**CANADIAN PROPOSAL TO AMEND FORMAL DOCUMENT TRANS/WP.29/2002/24
CONCERNING PROPOSED GUIDELINES REGARDING PROPOSING AND DEVELOPING OF
GLOBAL TECHNICAL REGULATIONS**

Figure 1. GTR development process

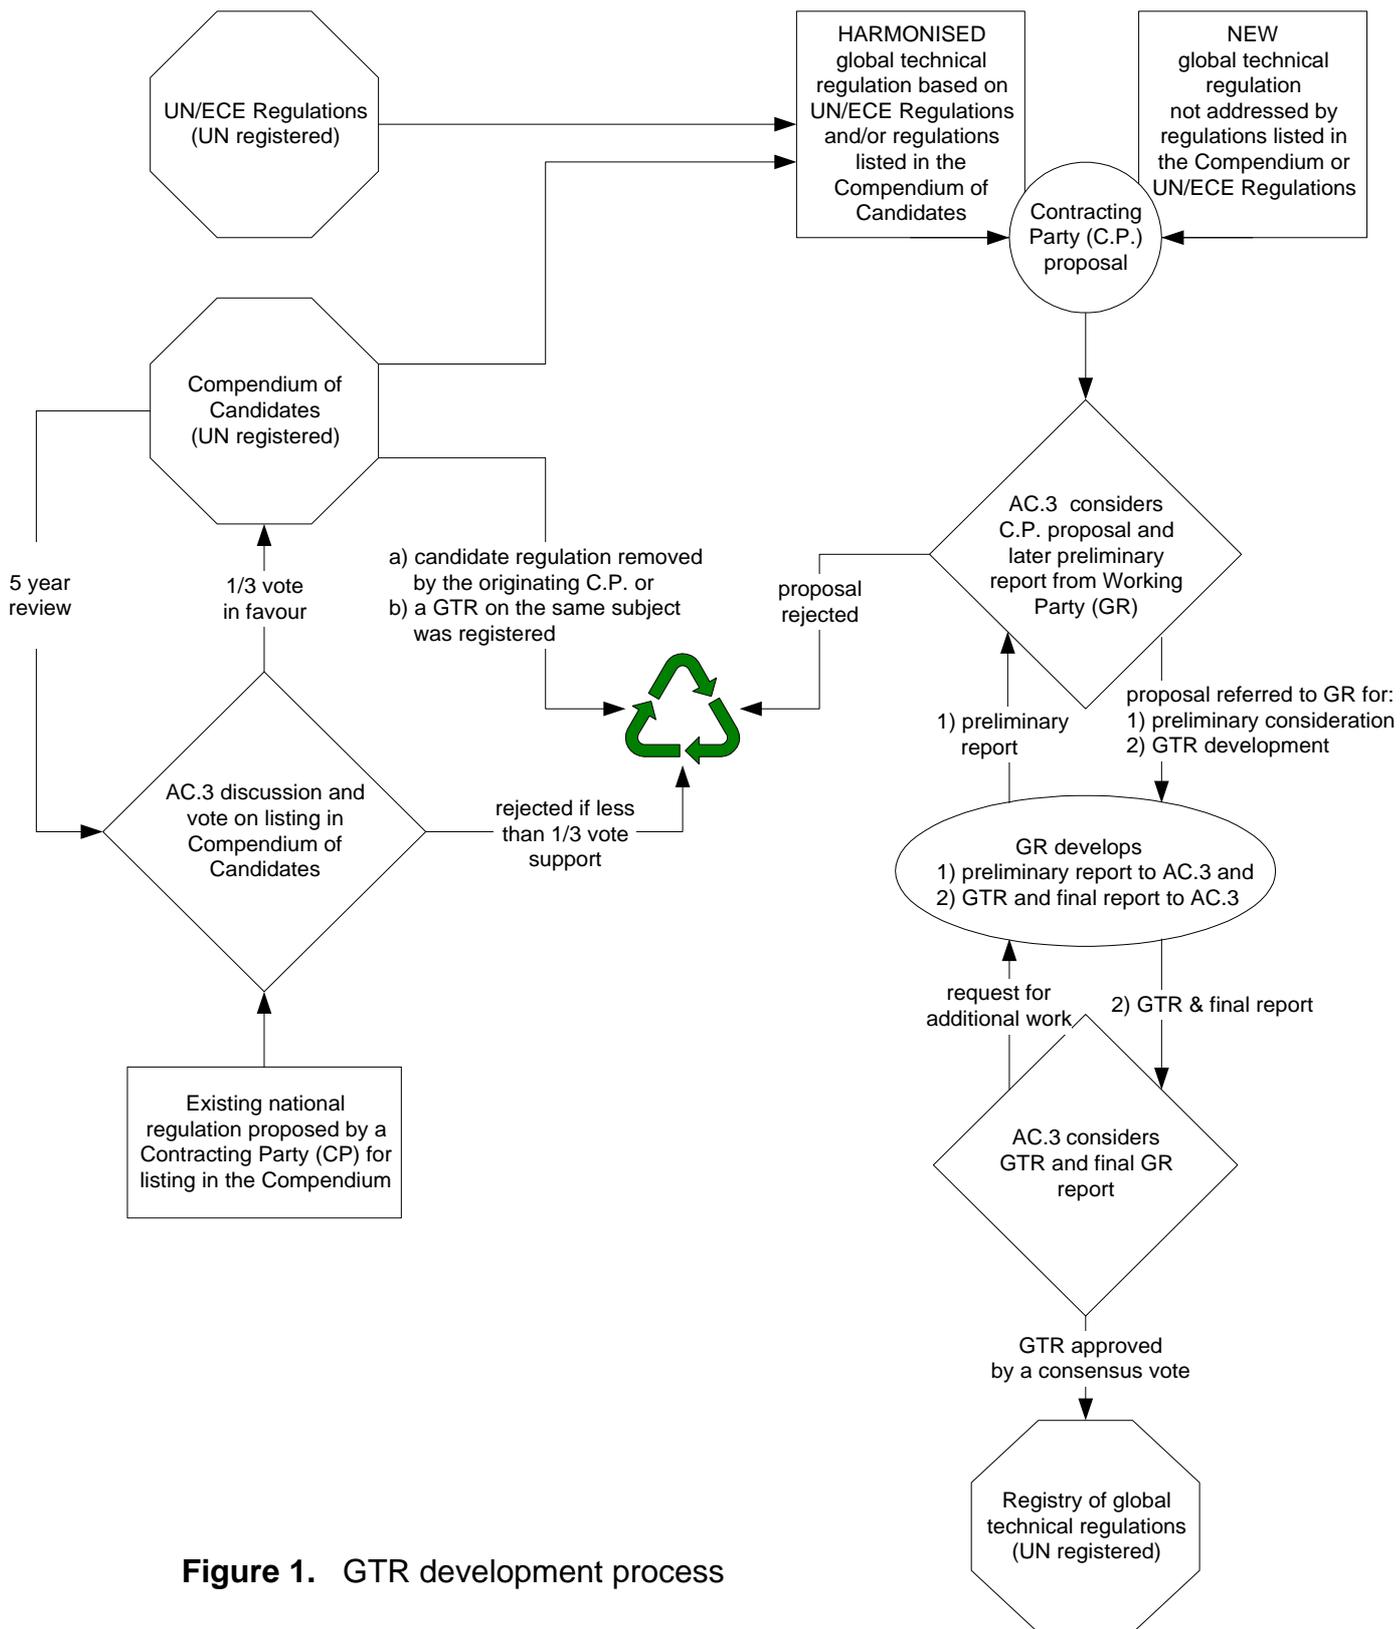
Add Figure 1. depicting the GTR development process.
